PEACH BOTTOM ATOMIC POWER STATION, UNIT NO. 3

AMENDMENT TO FACILITY OPERATING LICENSE

Amendment No. 107  
License No. DPR-56

ATTACHMENT TO LICENSE AMENDMENT NO. 107

FIGURE 3.5.K.2 MCPR OPERATING LIMIT vs  $T$

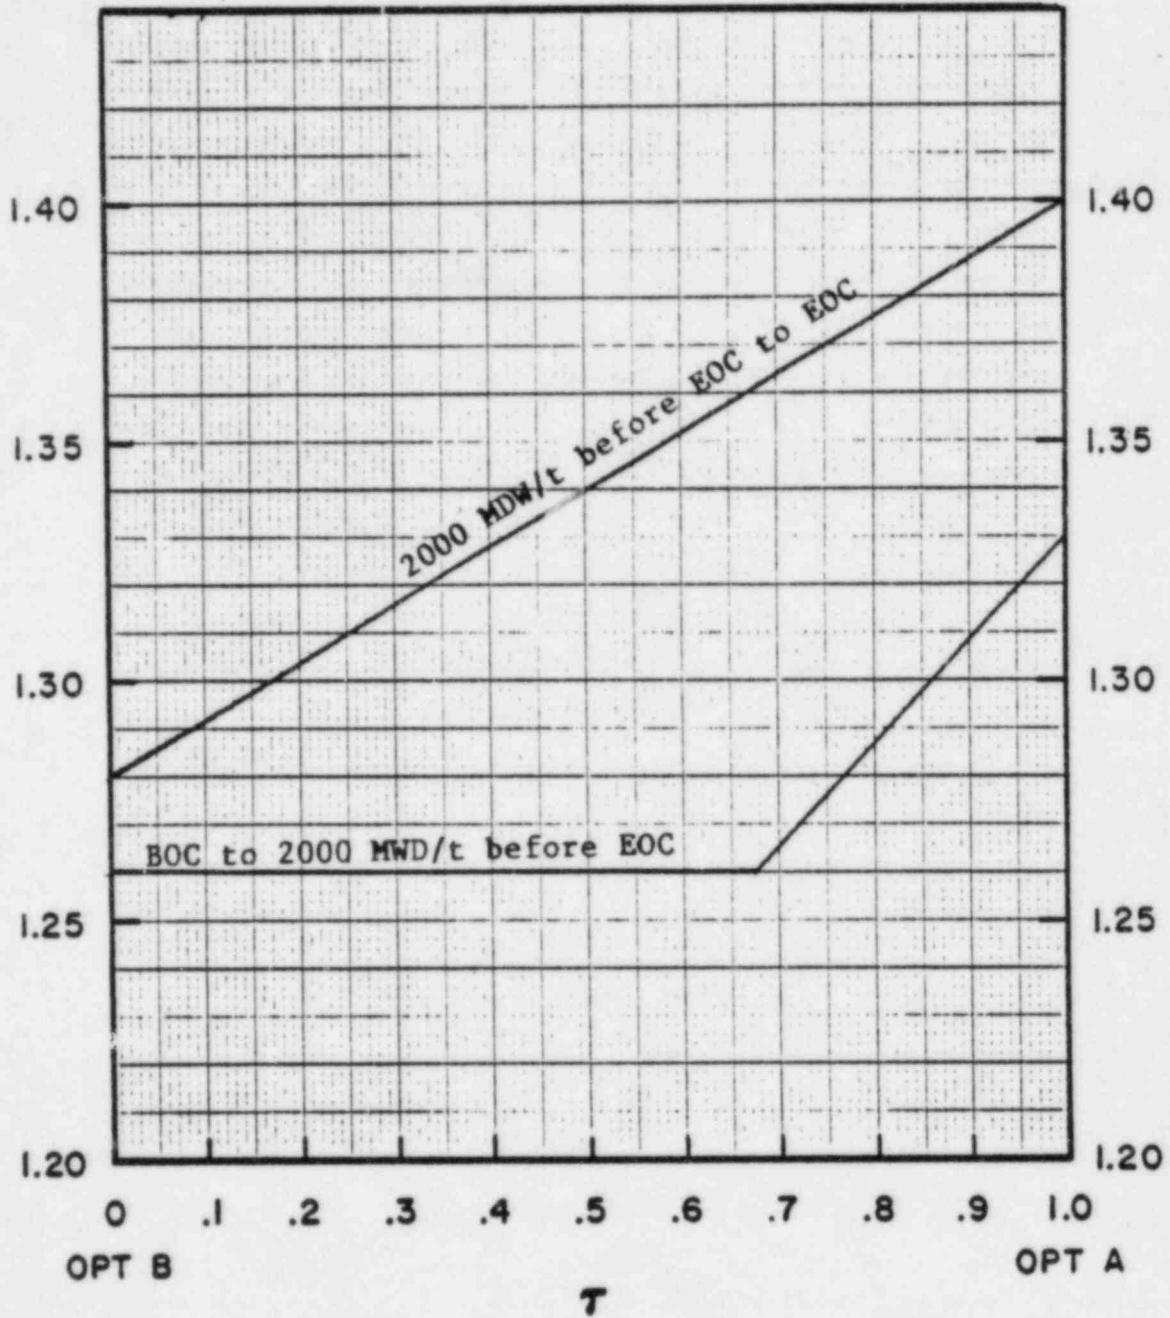
Table 3.5.K.2

OPERATING LIMIT MCPR VALUES  
FOR VARIOUS CORE EXPOSURES\*

<u>Fuel Type</u>	<u>MCPR Operating Limit For Incremental Cycle Core Average Exposure**</u>	
	BOC to 2000 MWD/t Before EOC	2000 MWD/t before EOC To EOC
PTA & PSX8R	1.26	1.28
LTA	1.26	1.28

\* If requirement 4.5.K.2.a is met.

\*\* These values shall be increased by 0.01 for single loop operation.

Table 3.5.K.3

OPERATING LIMIT MCPR VALUES  
FOR VARIOUS CORE EXPOSURES\*

<u>Fuel Type</u>	<u>MCPR Operating Limit For Incremental Cycle Core Average Exposure**</u>	
	<u>BOC to 2000 MWD/t Before EOC</u>	<u>2000 MWD/t before EOC To EOC</u>
PTA & PBXSR	1.33	1.40
LTA	1.33	1.40

\* If surveillance requirement of section 4.5.K.2 is not performed.

\*\* These values shall be increased by 0.01 for single loop operation.
